Comments on “Numerical investigation and circuit analysis of interdigitated photoconductive antenna for terahertz applications”

The work “Numerical investigation and circuit analysis of interdigitated photo-conductive antenna for terahertz applications” presents an equivalent circuit model for terahertz antennas with an interdigitated topology. In this work, the proposed model is used to enhance the antenna efficiency by optimizing the structural parameters of the interdigitated topology. However, several equations used in the model presents inconsistencies that directly affects the presented results of circuit model. In the present communication we discusses the inconsistencies in the proposed model assumptions and respectfully suggest possible corrections.

Fig. 1 Antenna geometry with fingers and gap dimensions

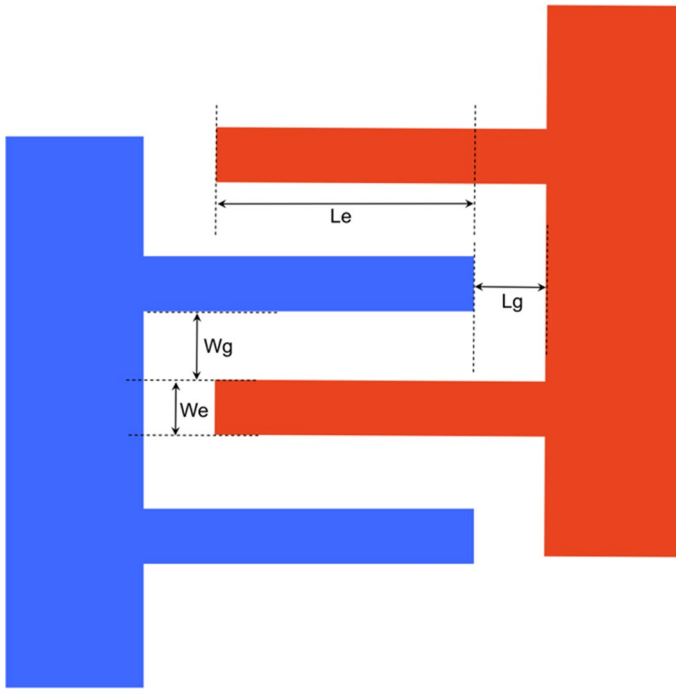
The expression for the equivalent gap conductance reported in equation 4 includes an incorrect definition of the active area. At this point in the article, two different definitions for the active area have been defined (A_a, A), which is confusing and misleading to the readers. Furthermore, the latest definition denoted by the authors as (A) does not correspond to a canonical definition of area. Specifically, the authors defined it by adding two different widths (W_g) and (W_e). his definition needs at least a length term, which must be multiplied by the width. This error in estimating the active area directly impacts the magnitude and units of the time-dependent conductance in equation 4, thus affecting the results of the message in the article.

We suggest adding a figure with the antenna geometry to clarify all the antenna dimensions referred to in the equations (W_g, W_e, L_g, L_e). For example, assuming that the antenna presents the geometry in Fig. 1, the active area could be approximately defined as $A = N_g(W_g L_e) + N_e(W_e L_g)$. Note that this definition includes width and length dimensions, which agree with a canonical area definition.
